Preservation Department – Item 1, LPC-22-08731

**6301 12th Avenue, aka 6301-6323 12th Avenue, 1202-1216 63rd
Street, and 1201-1215 64th Street – Angel Guardian Home –
Individual Landmark
Borough of Brooklyn**

LPC-22-08731: 6301 12th Avenue, Angel Guardian Home - Individual Landmark

PUBLIC MEETING SCOPE 09/20/2022

TYPICAL SECTIONS WITH LIGHT POLES:

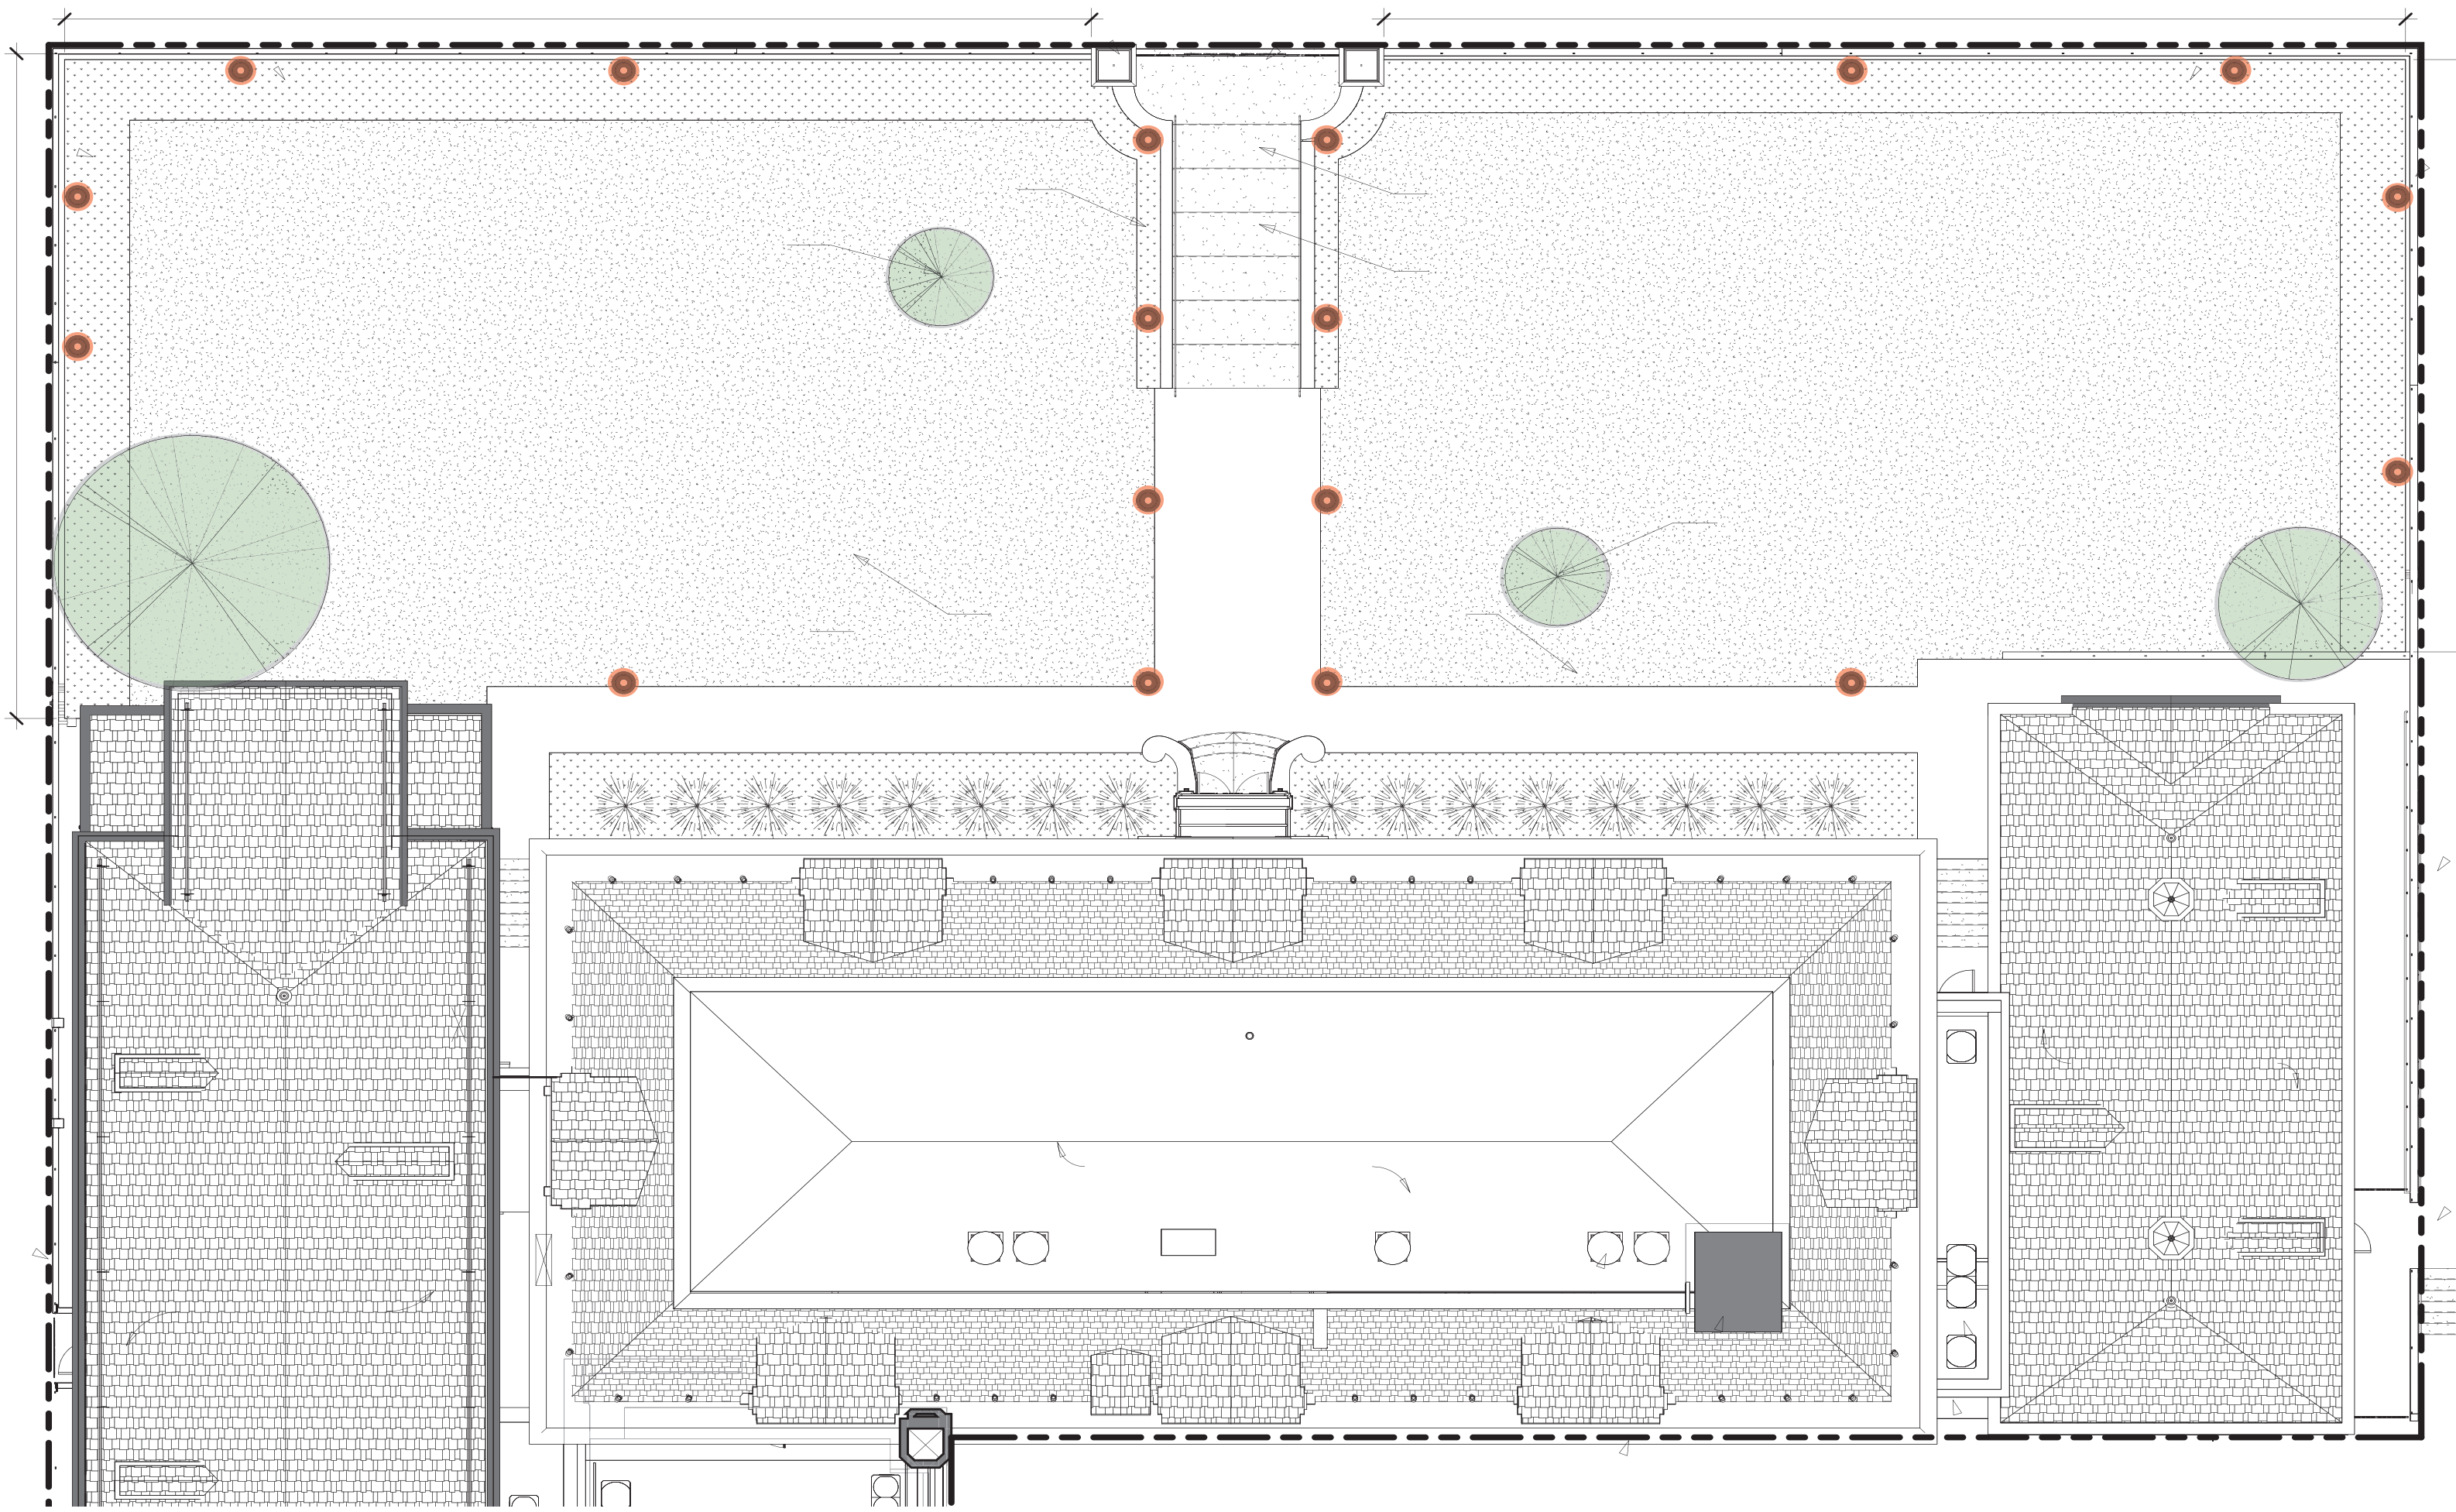
- TREE IN FRONT OF 63RD ST WING TO BE REMOVED
- ADDITIONAL TREES ADDED
- REVISED LIGHT POLE PLACEMENT (LESS POLES, MORE SPACED OUT)
- MAIN BUILDING FACADE LETTERING SHORTENED
- LETTERING ON ARCH REMOVED

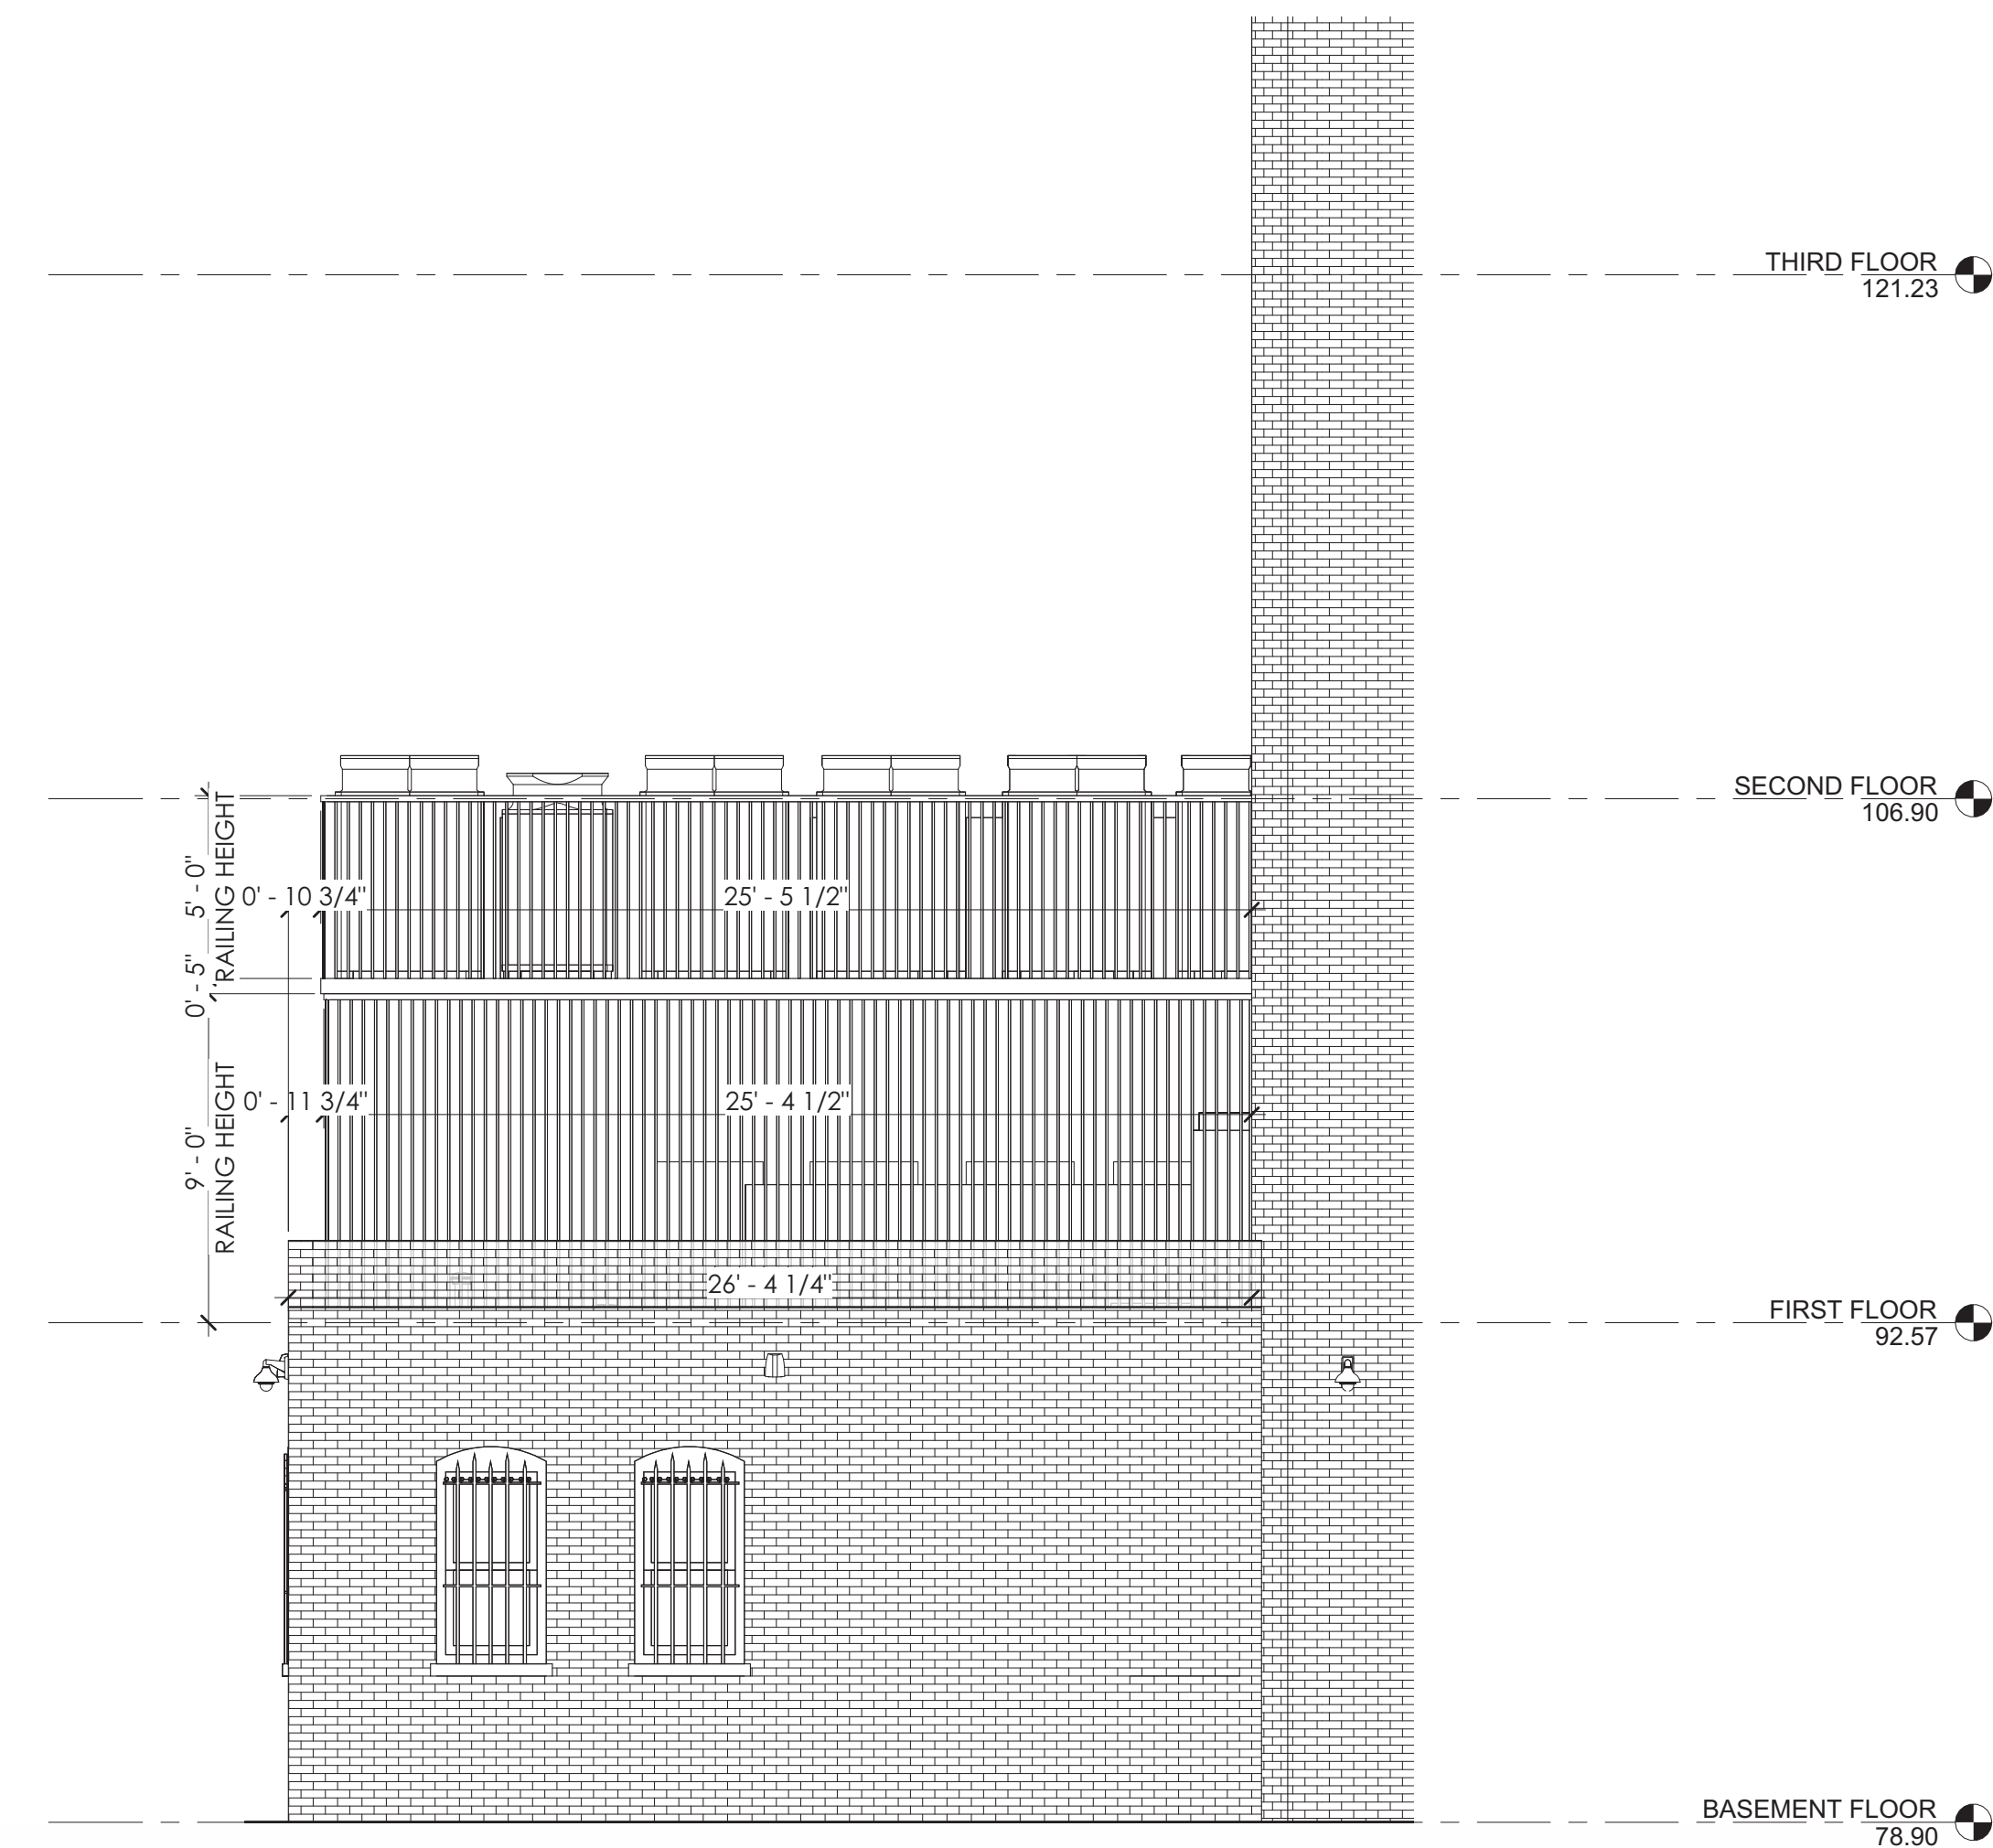
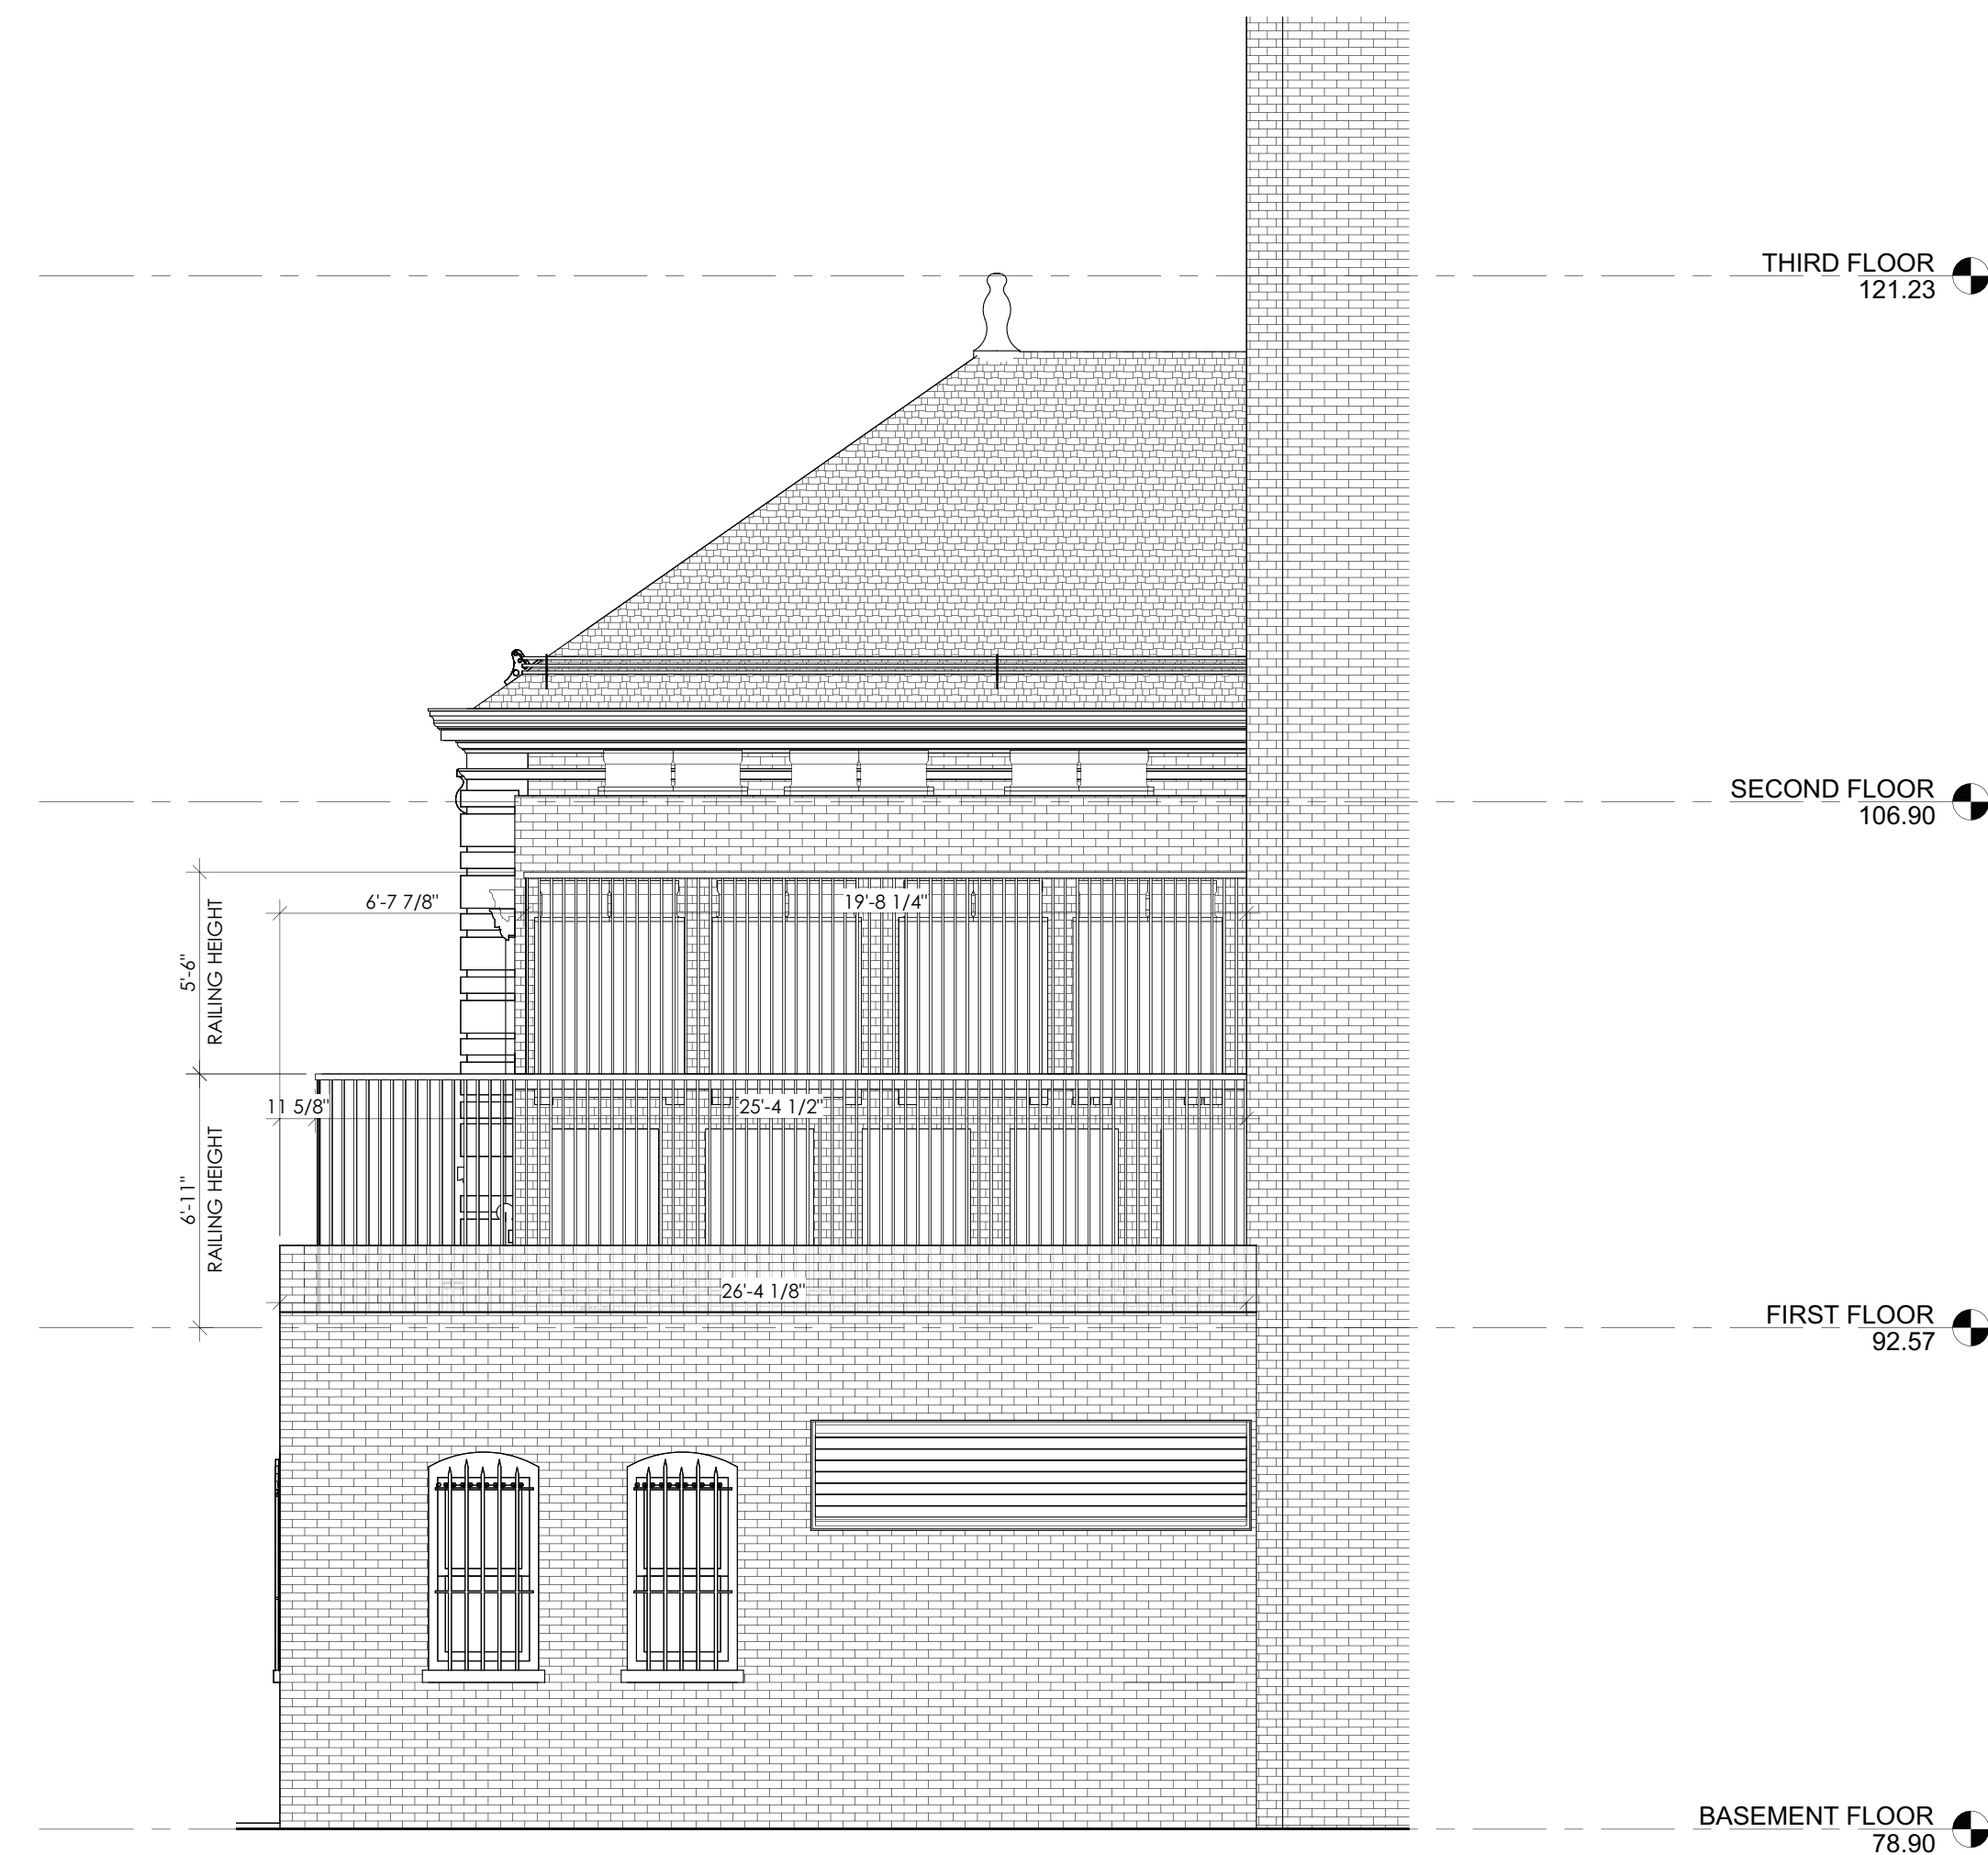
- CHANGES:**
- RAISED HEIGHT OF FIRST LEVEL DUNNAGE
 - REMOVED SECOND LEVEL DUNNAGE SETBACK
 - WIDE MECHANICAL LOUVRE REMOVED
